World Forum for Harmonization of Vehicle Regulations

Working Party on Noise

Report of the Working Party on Noise on its sixty-sixth session

Adopted amendments to Regulation No. 51 (based on ECE/TRANS/WP.29/GRB/2017/6)

Figure 2: Flowchart for the check on the necessity for a silencer conditioning test

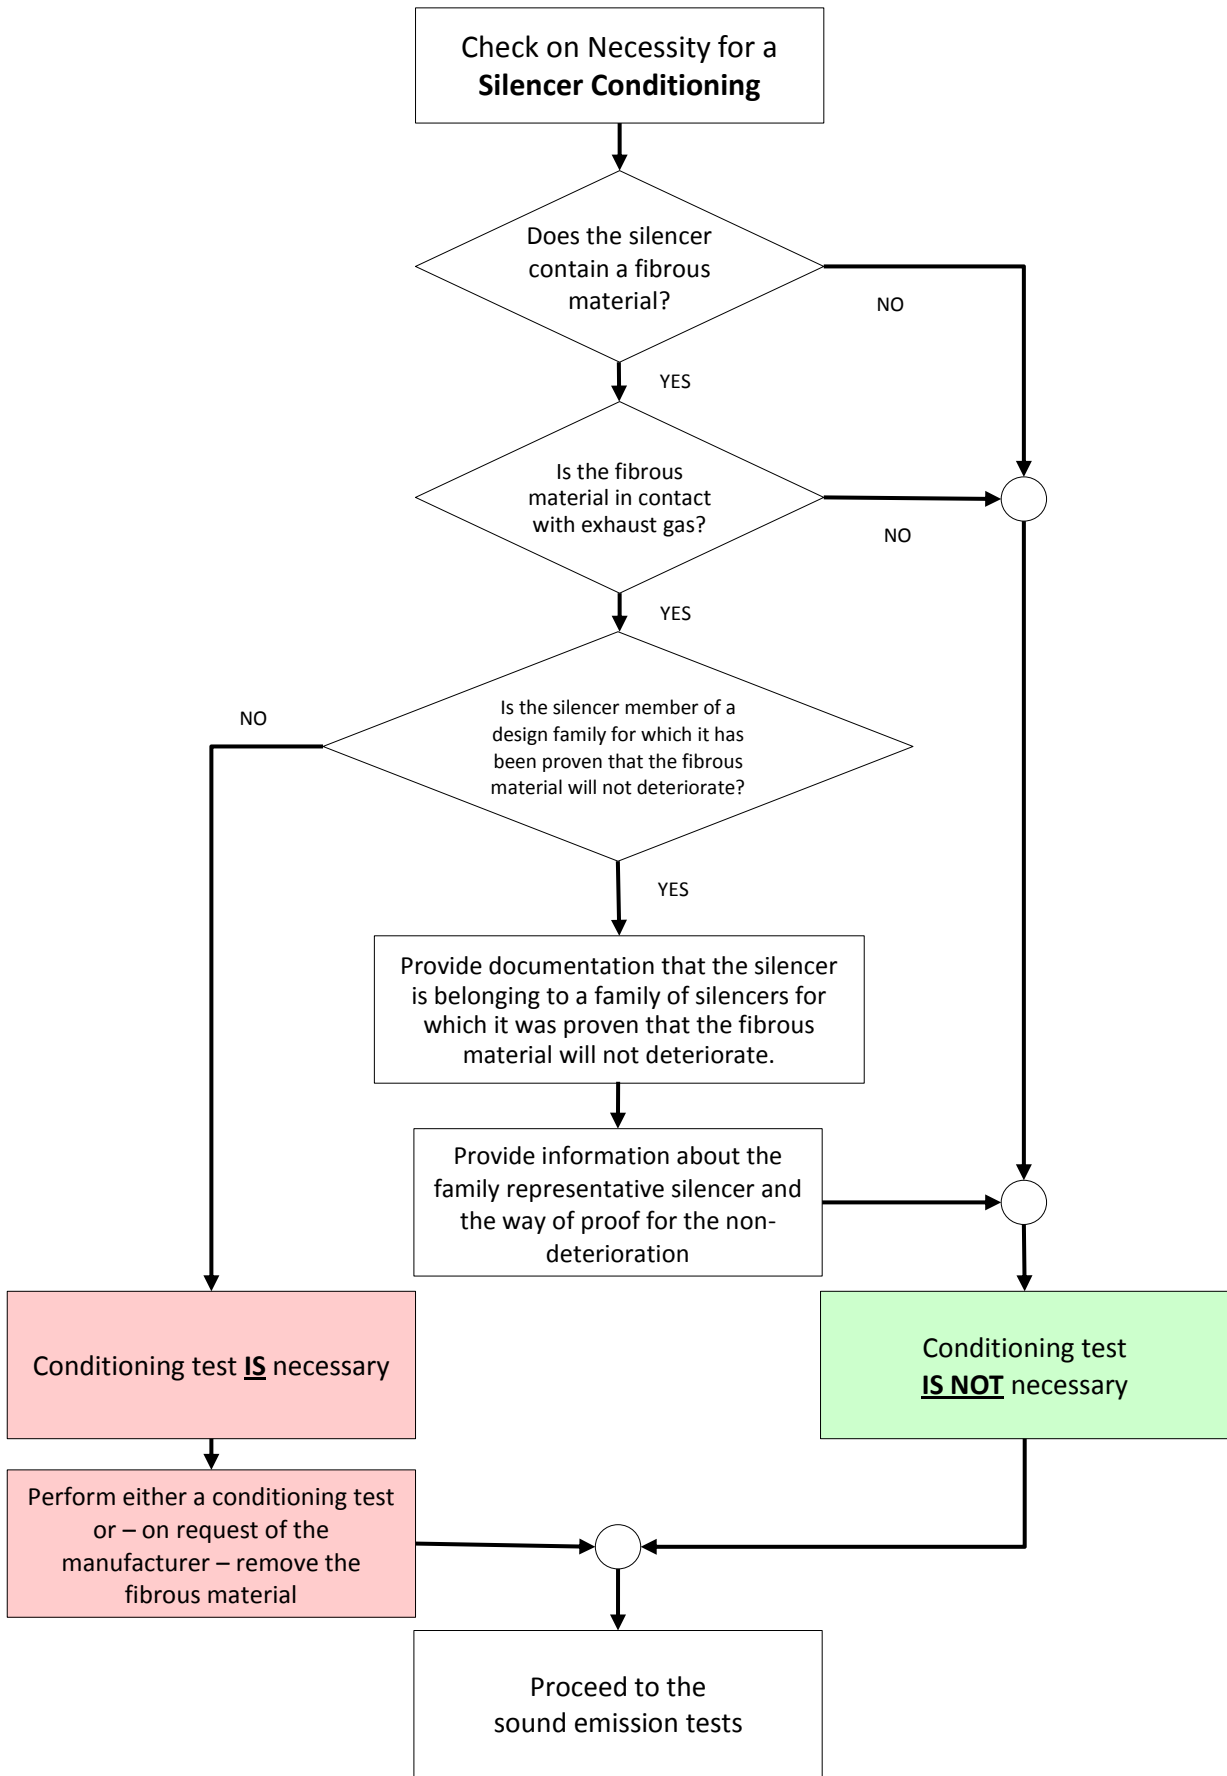
"2.2.6. If the vehicle is equipped with an exhaust system containing fibrous materials, ~~the exhaust system is to be conditioned before the test according to Annex 4~~ it might be necessary to carry out a conditioning test prior to testing. The provisions of Annex 4, paragraph 1 in conjunction with the flowchart (figure 2) of the appendix to Annex 4 shall be followed."

Appendix, add a new flowchart to read:
